Town of Simsbury

Office of Community Planning and Development

To: Simsbury Design Review Board

RE: Application ZC #24-07 of 34 Hopmeadow St. Realty Co, LLC, a site plan

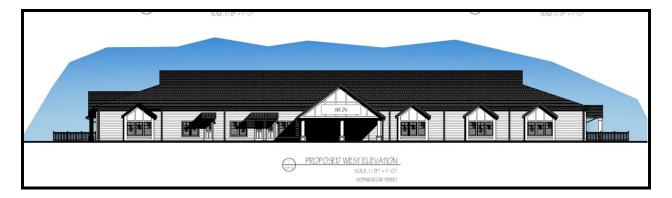
The site plan orients the building parallel to Hopmeadow Street and setback significantly (260 feet) due to the setback requirement of the original PAD. Parking (50 spaces) is shown up front with the open play areas on three sides. Not shown on the color version below, the stormwater facility is located on the southern portion of the property adjacent to the play area and entrance street.

- Staff recommends additional landscaping, especially in and around the stormwater facility.
- Is there either a functional or architectural value to a more pronounced drop-off area with a *bona fide* port-a-cochere?

- Is there a particular reason the street tree plantings are set 100 feet into the site? Should they be closer to Hopmeadow?
- Please note that sign plans have not been submitted at this time.
